Preliminary Consultation
MONTGOMERY COUNTY HISTORIC PRESERVATION COMMISSION STAFF
REPORT

Address:	8700 Colesville Road, Silver Spring	Meeting Date:	9/19/18
Resource:	Montgomery Arms Apartments	Report Date:	9/12/18
	Individually Listed Master Plan Site		
Review:	Preliminary	Public Notice:	9/05/18
Case Number:	36/07-002A	Tax Credit:	No
Applicant:	Corey Pitts, Montgomery County DOT	Staff:	Rebecca Ballo
Proposal:	Construction of a Bus Rapid Transit (BRT) station and associated signage

STATION 2 - SB FENTON STREET

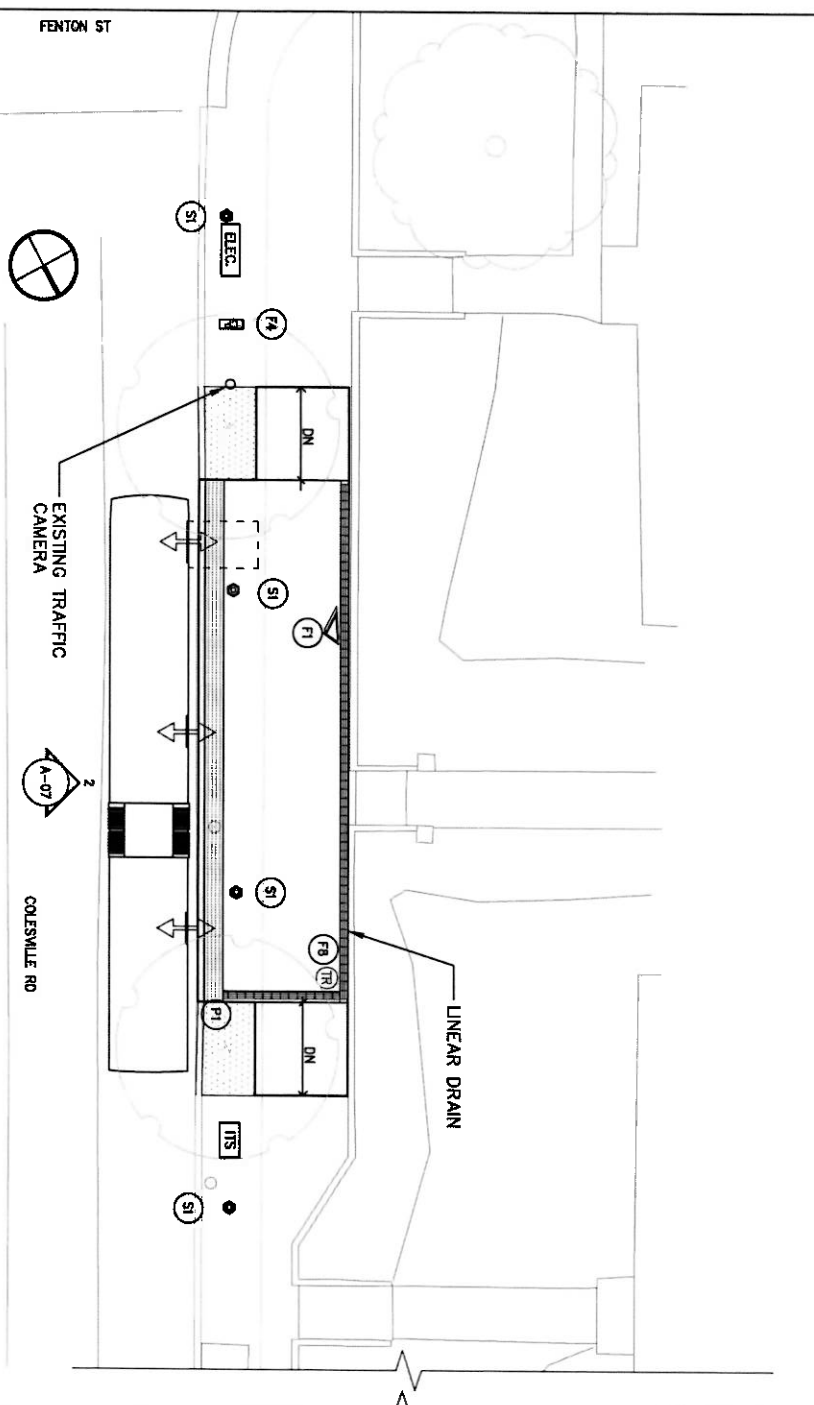
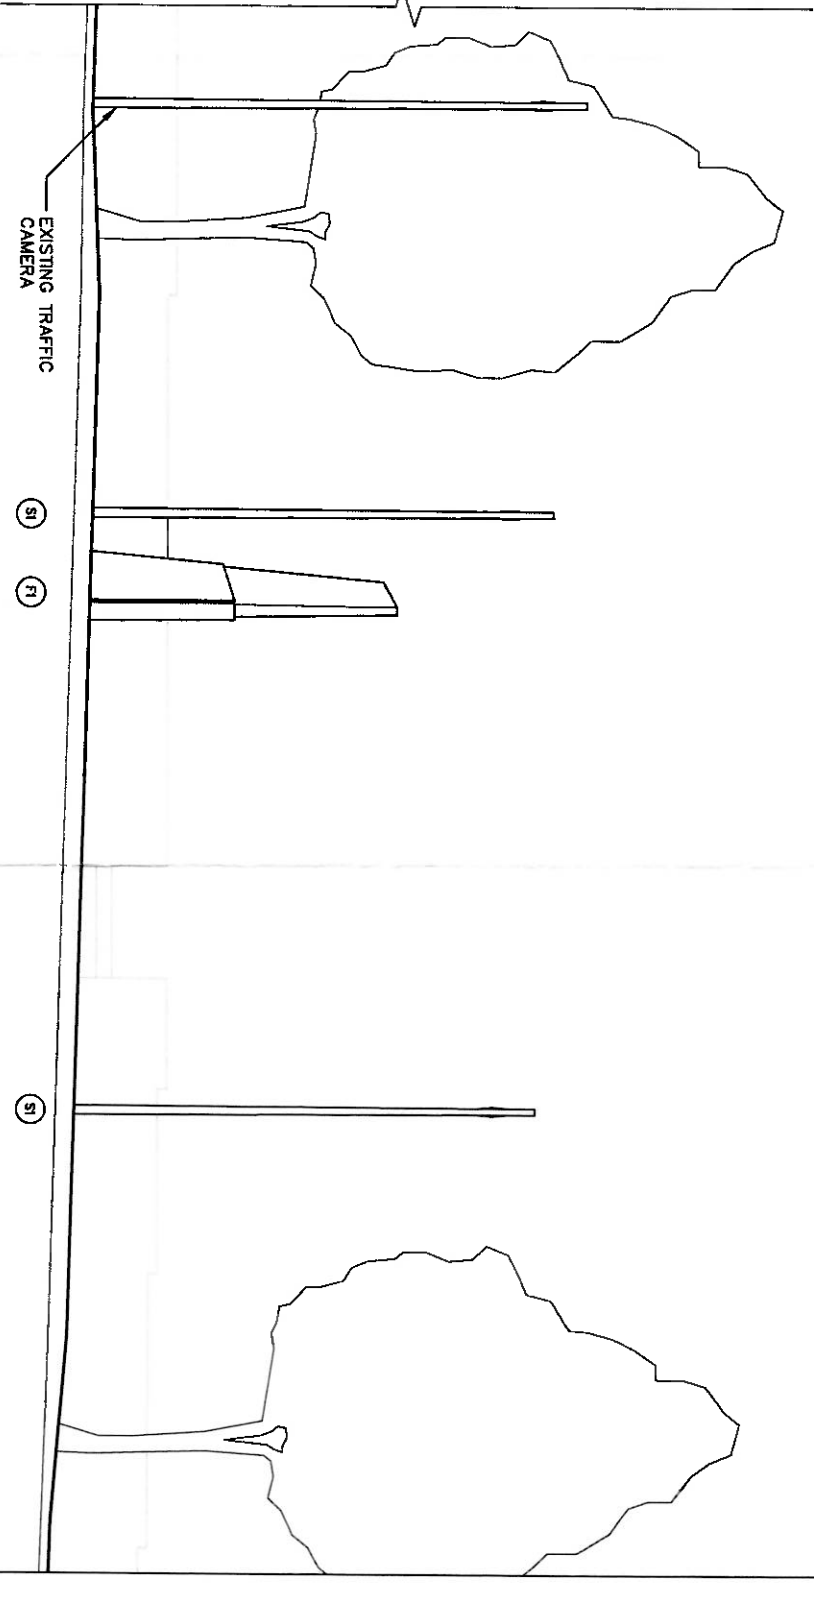
The proposed station marker for this BRT stop is proposed to be located within the boundaries of the environmental setting. The marker is called out as F1 on the submitted site plan (Sheet 270 of 358). The marker would be located immediately adjacent to the kneewall of the apartment complex, to the left of the stairs leading from the sidewalk into the interior courtyard. As proposed, the station marker measures approximately 17' tall, with a triangular base, tapering in width as the height increases. The base of the marker would be clad in a stone veneer, and the upper portions would be sheathed in powder coated metal, with a continuous horizontal band of LED lights spanning both materials. An integrated touch screen and map would be positioned on the lower portion of the marker and would be ADA compliant. The canopies shown in the application are not proposed for this BRT station, but would be used elsewhere in the corridor.

While staff recognizes that the station marker is a modern element of a busy transit corridor, its proximity and proposed height so close to the adjacent kneewall of the historic apartment building is potentially incompatible. The renderings submitted for this preliminary consultation do not show the station marker in place with the adjacent historic site. Staff recommends that the

applicant submit viewshed studies and renderings that place this station marker in its proposed context within the historic site boundaries. Staff would also recommend that the applicant consider relocating this sign outside the historic site boundaries, and/or consider a design that is not so tall.
